MANDATORY SERVICE BULLETIN NO.
MSB 40-103 / MSB F4-042 / MSB D4-114 / MSB 40NG-084
REV. 1

Actions to prevent Passenger Door Separation: Installation of Placards, AFM Procedure update and Inspection/Data Gathering.

WORK INSTRUCTION
WI-MSB 40-103 / WI-MSB F4-042 / WI-MSB D4-114 / WI-MSB 40NG-084
REV. 1

Installation of passenger door placards and inspection of the passenger door system.

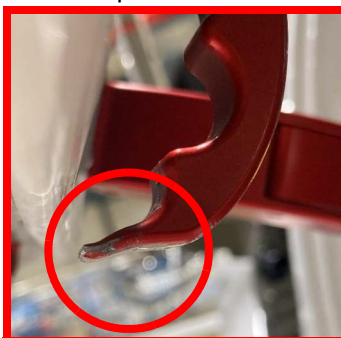
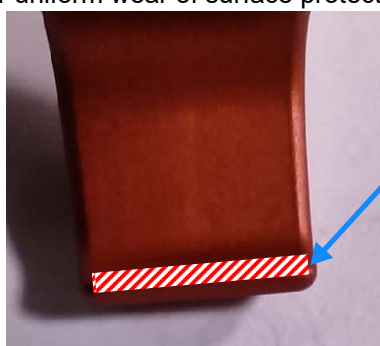
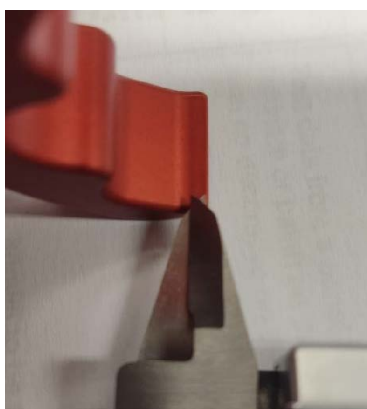
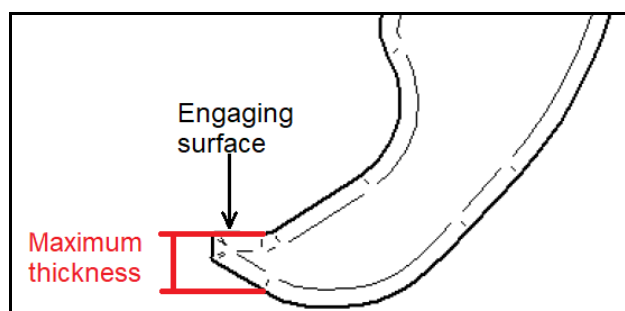
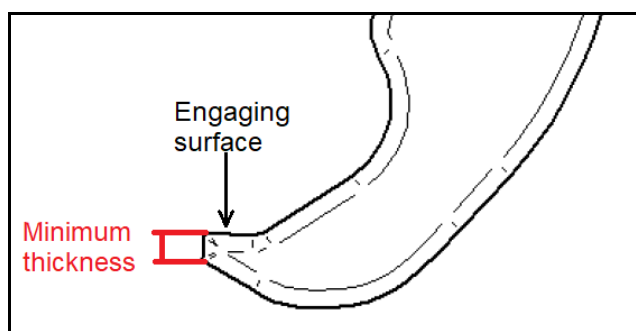
5. Examine the safety hook for signs of wear, corrosion and poor condition:
Record the condition of the hook on the execution report in Appendix A.

- a) Check the contact area of the push button.
- Grooves in the safety hook must be less than 2 mm deep.

- Wear of edges of safety hook.
- The width of the tip of the safety hook must be greater than 10.5mm.

- It must not have any steps and ridges.
- Scratches or uniform wear of surface protection are acceptable.

- The width must be greater than 1.5 mm.

- h) If the safety hook does not meet one or more of the acceptable conditions listed above on sub-steps **a** through **g**, take note to replace the safety hook after this WI is completed. Refer to Section IV for replacement of the safety hook.

Figure 2.

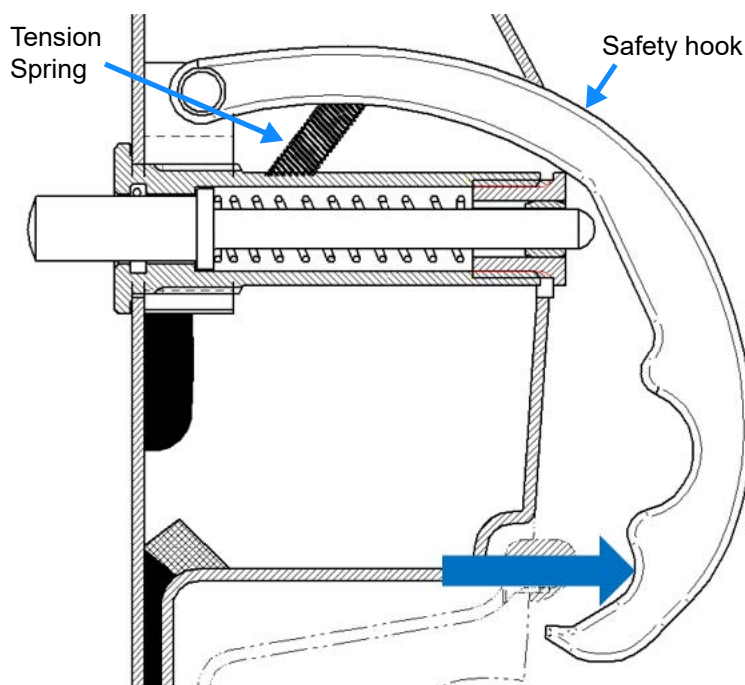
6. Check the condition of the tension spring and the force to lift the safety hook from its resting position as follows:
Refer to Figure 2.
- Open the passenger door.

- Lift the safety hook and release it.
 - After releasing the force, the safety hook must snap back into its resting position.
 - If the safety hook does not snap back into its resting position, do the following:

- If correction/replacement of any part is required, take notes and do it after this WI is completed. Refer to Section IV for removal and installation of the hook assembly.

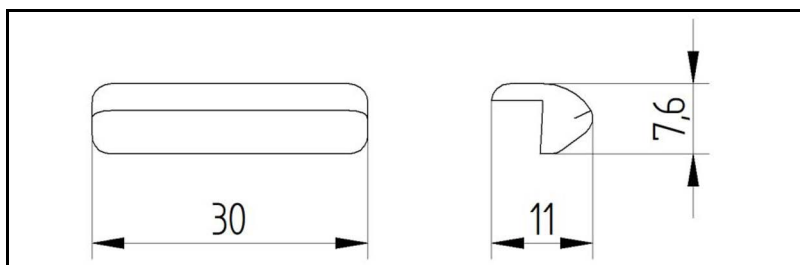
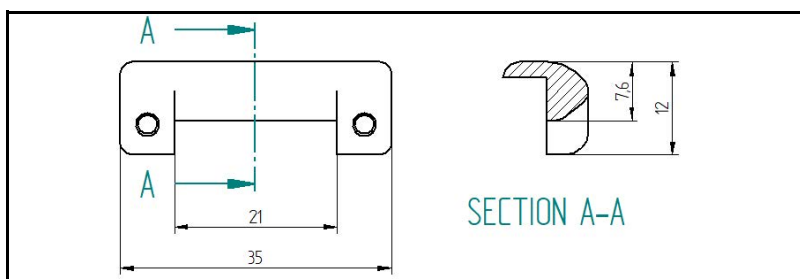
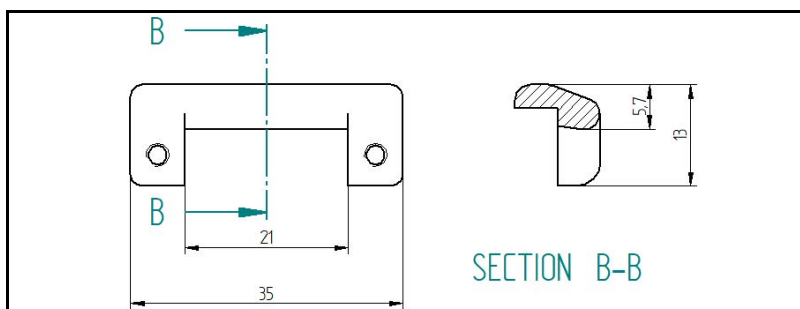
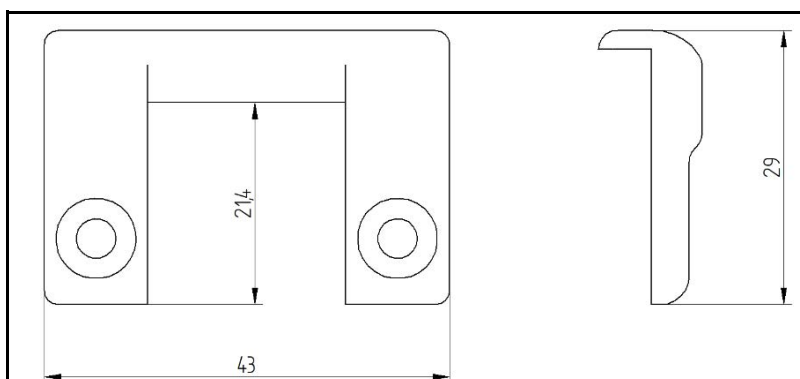
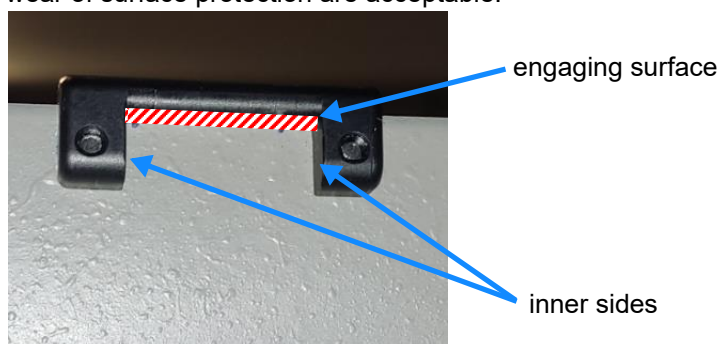
7. Identify the version of the retaining block:
Record the version in the execution report.

Small (DA4-5200-00-69)

Extended without undercut (DA4-5200-00-69_1)

Extended with undercut (DA4-5200-00-69_02)

Long extended (DA4-5200-00-69-SB)

8. If retaining block DA4-5200-00-69 is installed (refer to step 7):
 - a) Replace the retaining block according to MSB40-070 / MSBD4-079 / MSBF4-024.
 - b) Record the replacement of the retaining block on the execution report in Appendix A.
9. Examine the retaining block for signs of wear, corrosion and poor condition.
 - There must be no corrosion on the retaining block.
 - Wear at the inner sides of the retaining block must be less than 0.5 mm per side.
 - The engaging surface of the retaining block and the edge of the engaging surface that is facing the retaining block must not have any steps and ridges.
 - Scratches or uniform wear of surface protection are acceptable.

Figure 4.

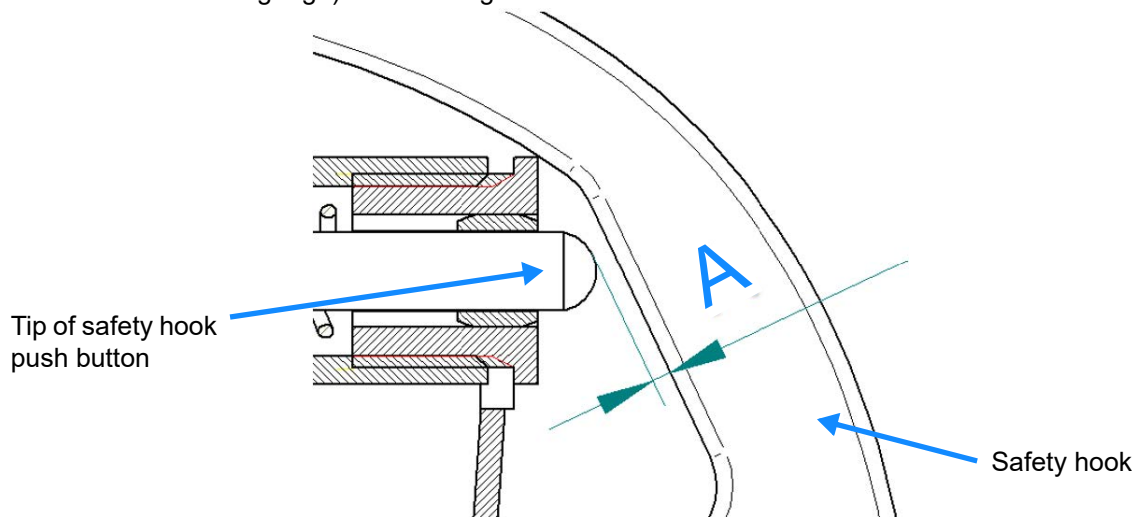
- Dimension A: distance of push button to the safety hook in resting position (e.g. with a feeler gauge). Refer to Figure 4.

Figure 5.

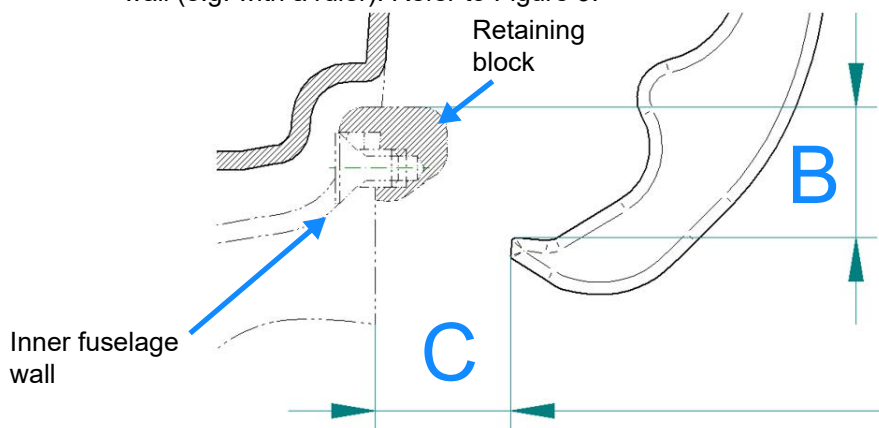
- Dimension B: distance between the top surface of the retaining block to the top surface of the engaging section of the safety hook in resting position (e.g. with a ruler). Refer to Figure 5.
- Dimension C: horizontal distance between the tip of the safety hook and the fuselage wall (e.g. with a ruler). Refer to Figure 9.

Figure 6.

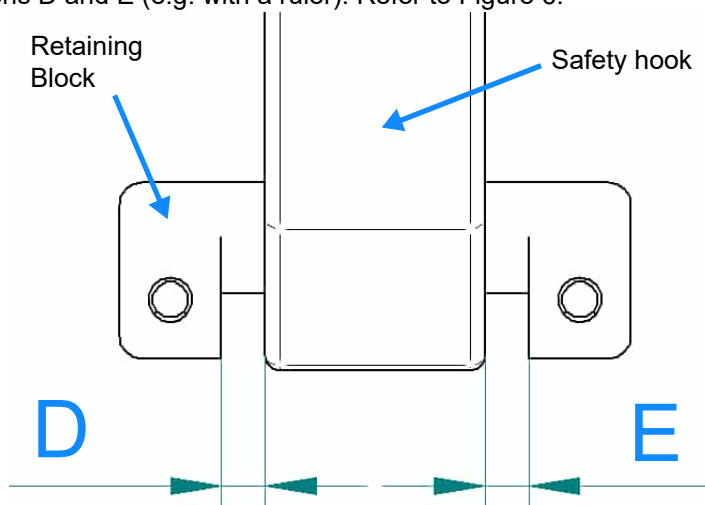
- Dimensions D and E (e.g. with a ruler). Refer to Figure 6.

Figure 10.

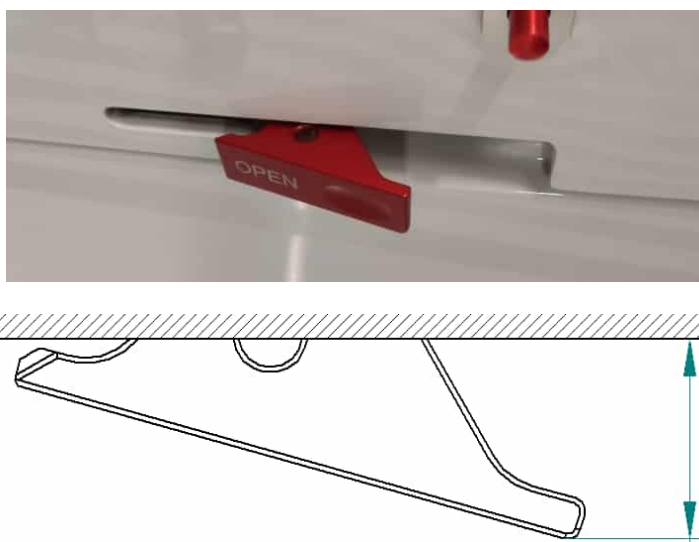
15. If the old passenger door latch is installed (refer to step 14), visually inspect the spring:
Refer to Figure 10.
- a) Move the passenger door handle to the unlatched position.
 - b) Visually inspect the spring.
 - Look specifically for a broken winding, replace the spring if found broken.
 - c) Record any findings on the execution report in Appendix A.

Figure 11. Protrusion measurement

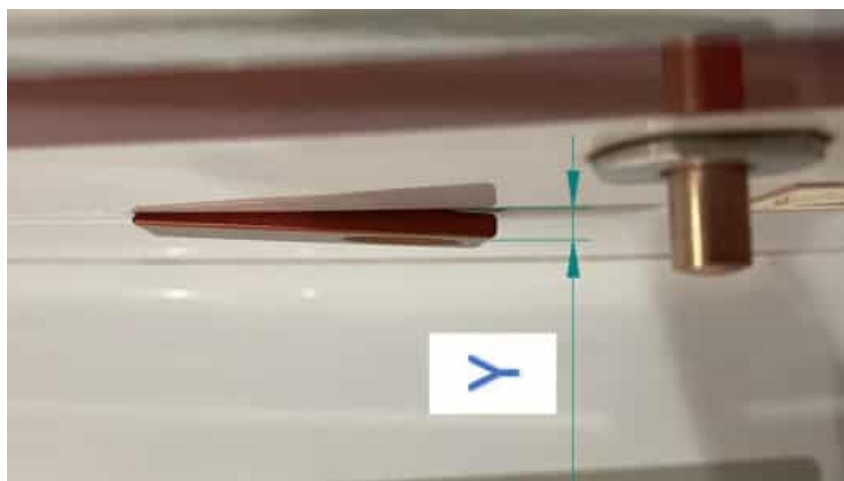
19. Data collection: Position of the external passenger door handle. Refer to Figures 11 and 12.

- a) Close the passenger door.
- b) Push the external passenger door handle into the latched position until it stops.
- c) Examine if the passenger door handle is recessed, flush or protruding over the passenger door surface.
- d) Record the condition of the passenger door handle on the execution report in Appendix A.
- e) If the handle protrudes from the surface of the passenger door, measure the protrusion.
- f) Record the measurement on the execution report in Appendix A.

Figure 18. Example of **NOT** acceptable condition of door guide block

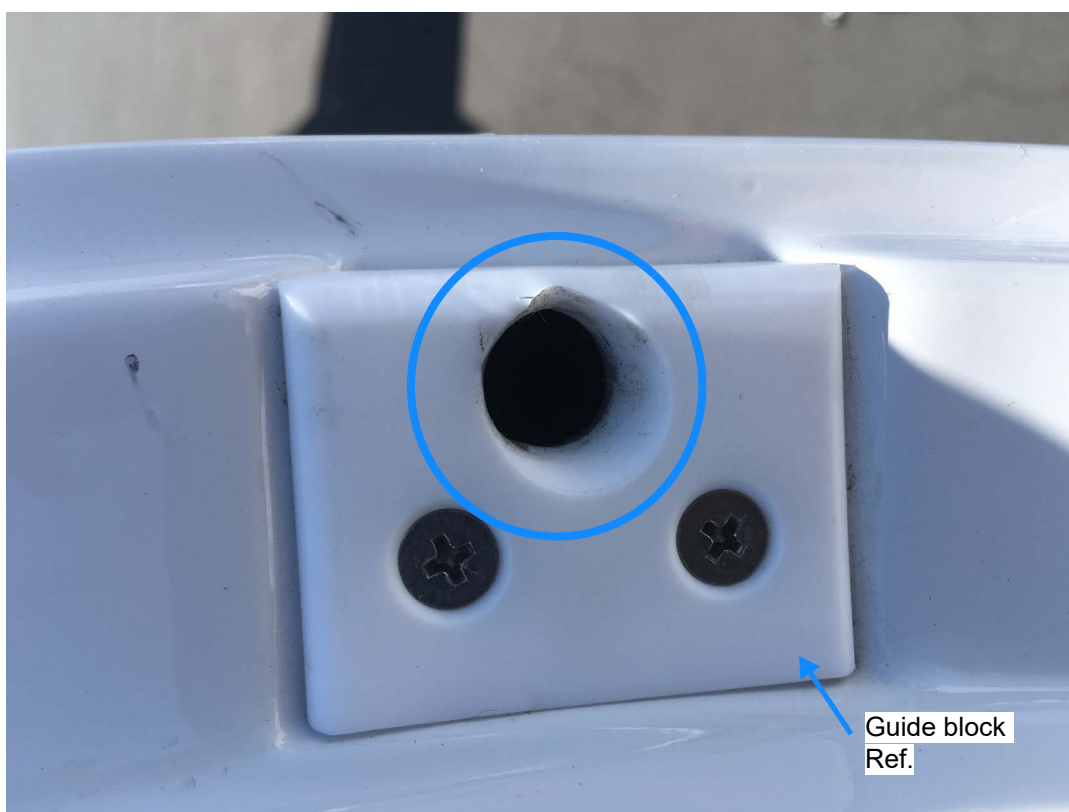
23. Inspect the front and rear door guide block for damage. Refer to Figure 18.

- a) Open the passenger door.
- b) Visually check the condition of the guide block.
 - The guide block must not have worn edges, dents, cracks.
 - If you found any damage, take note and replace the guide block after the WI is completed. Refer to section IV for the replacement.
 - Record any damage of the guide blocks on the execution report in Appendix A.

1. Remove the 2 screws that attach the guide block and remove it from aircraft.
2. Install new guide block (item 20 and/or 21) with 2 screws (item 22). Use Loctite 241 or 243 (item 7 or 7a) to screw, refer to manufacturer instructions for proper use.

Figure 29.

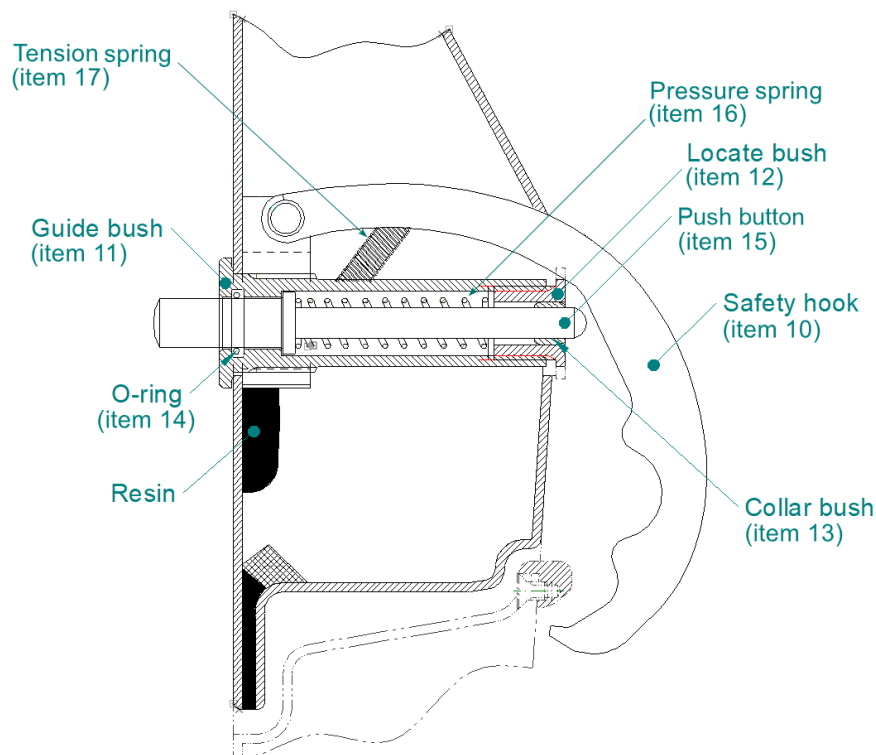
Refer to Figure 29.

1. Remove the inner door handle to get access to the inside of the door. Refer to AMM Section 52-10.
2. Unscrew the guide bush and locate bush to release the push button assembly.

3. Remove the hook assembly from aircraft through the handle opening and place it on a work table to replace safety hook.
4. Remove screw that secures the tension spring on the safety hook.
5. Remove cotter pin to release safety hook, pin and washers.
6. Install the new safety hook (item 10) using the pin, washers and cotter pin.
7. Reinstall tension spring using the screw to secure it. Use Loctite 262 (item 6) to screw, refer to manufacturer instructions for proper use.

8. Replace any defective parts of the push button.
9. Reinstall hook assembly to the aircraft door:
 - a) Route the hook assembly through the handle opening and secure to outside door shell with guide bush (item 11).
 - b) Insert collar bush (item 13) into locate bush (item 12).
 - c) Apply a small amount of Vaseline (item 8) to o-ring (item 14) and insert into guide bush.
 - d) Insert push button (item 15) and pressure spring (item 16) into guide bush (item 11) and screw guide bush and locate bush (item 12) together.
 - e) Apply ITW Plexus MA300 (item 9) or thickened resin (5 min epoxy + cotton flakes) to the bearing block on the inside of the door. Refer to Figure 30 and the manufacturer instructions for proper use.
10. Record the replacement on the execution report in Appendix A.

Figure 31.

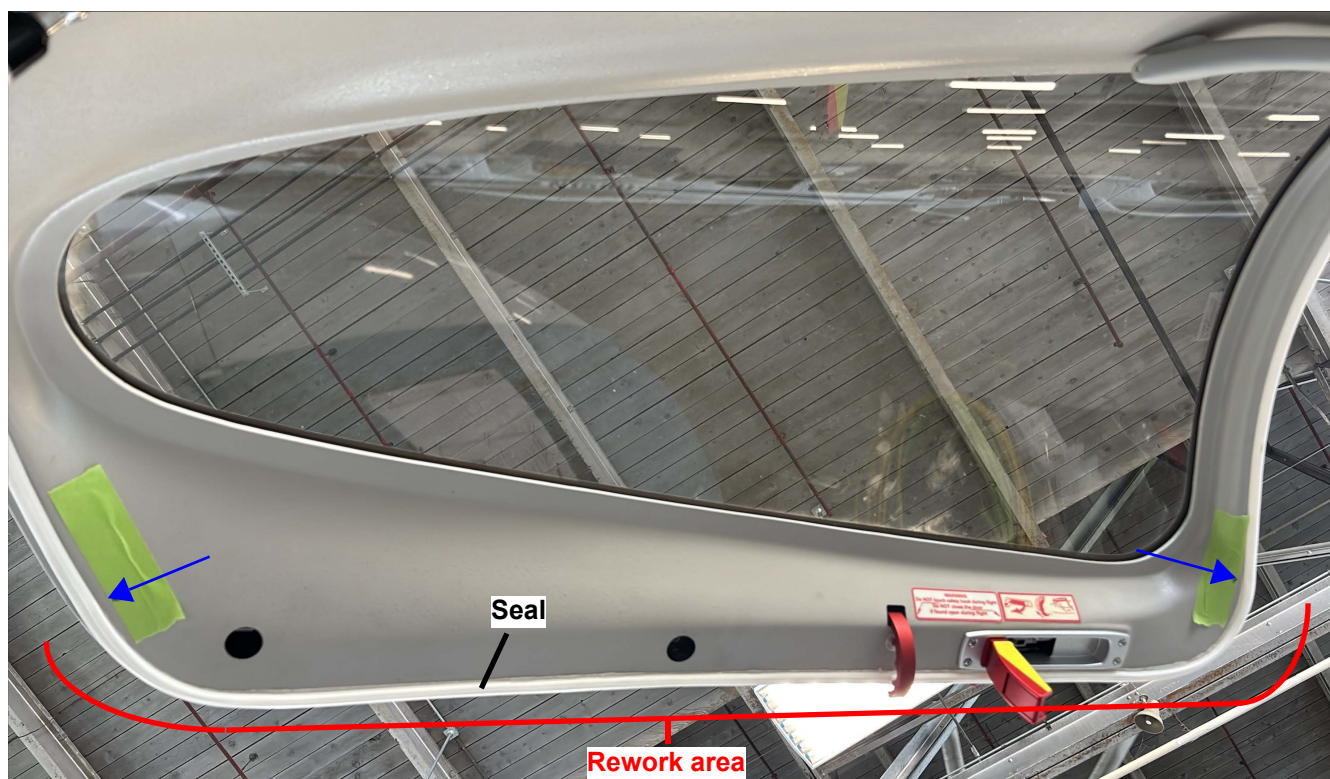
1. Carefully remove the door seal from the door only in the rework area specified in Figure 31. Be careful not to damage the seal during removal. Leave the seal hanging.
2. If required, remove existing sealant from the area where you removed the seal and clean the surface for the new sealant.
3. Apply 0-5 mm bead of clear silicone sealant (item 23) to the door.
4. Reinstall seal and allow sealant to cure. Refer to sealant manufacturers instructions.
5. Repeat step 20.c). and check if the force is between 2 kg (20 N) and 6 kg (60 N).
 - If the force is below 2 kg (20 N): Reapply sealant up to maximum allowed and repeat test. If test cannot be passed, replace gas spring.
 - If force is above 6 kg (60 N): Remove sealant, apply a thinner layer of sealant and repeat test.
